Access Compliance Report

Public Rights-of-Way

(Curb Ramps)

Intersection ID: 15324	Main Street: ELMHURST_RD	Cross Street: SOUTH_BV	Location: SE
ADA ID: 1C1006BA3FC6	Ramp Type: Perp	Initial Pass/Fail: Fail	Overall Compliance: No
		Severity Score: 12.5

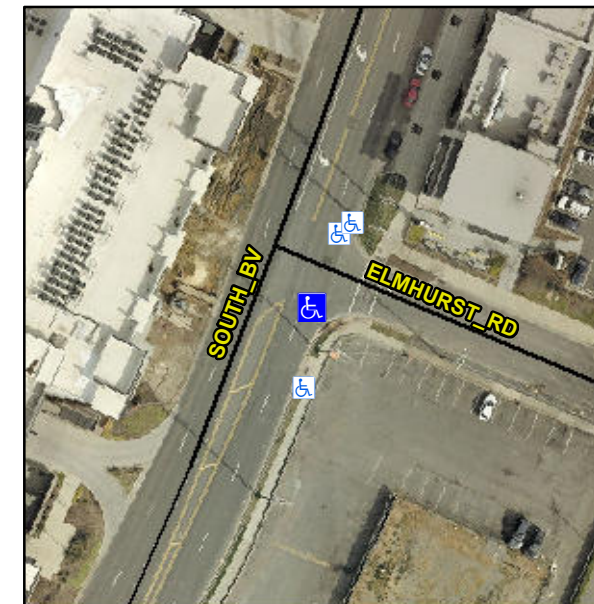
R304.2.2

Compliance	Description	Data	Compliance	Description	Data
N/A	Ramp Length (in)	47.0	No	Ramp Slope (%)	11.2
Yes	Ramp Width (in)	48.0	Yes	Ramp XSlope (%)	1.7
N/A	Flare Type LT	N/A	N/A	Flare Type RT	N/A
N/A	Flare Slope LT (%)	N/A	N/A	Flare Slope RT (%)	N/A
N/A	Flare Traversable LT?	N/A	N/A	Flare Traversable RT?	N/A
N/A	Landing Length (in)	N/A	N/A	DWS Provided?	N/A
N/A	Landing Width (in)	N/A	N/A	DWS Contrast?	N/A
N/A	Landing Slope (%)	N/A	N/A	DWS Length (in)	N/A
N/A	Landing X Slope (%)	N/A	N/A	DWS Full Width?	N/A
N/A	Landing Curb? (Y/N)	N/A	N/A	DWS Offset (in)	N/A
N/A	Shared Landing?	N/A			
N/A	Gutter Ponding?	N/A	N/A	Gutter Slope (%)	N/A
N/A	Gutter Lip Ht (in)	N/A	N/A	Gutter X Slope (%)	N/A
N/A	Painted X Walk1?	Yes	N/A	Painted X Walk2?	N/A
	X Walk 1 Direction	To NE		X Walk 2 Direction	N/A
N/A	X Walk 1 Width (in)	112.0	N/A	X Walk 2 Width (in)	N/A
	X Walk 1 Slope (%)	1.3		X Walk 2 Slope (%)	N/A
	X Walk 1 X Slope (%)	1.2		X Walk 2 X Slope (%)	N/A

Remove & Replace Entire Ramp.
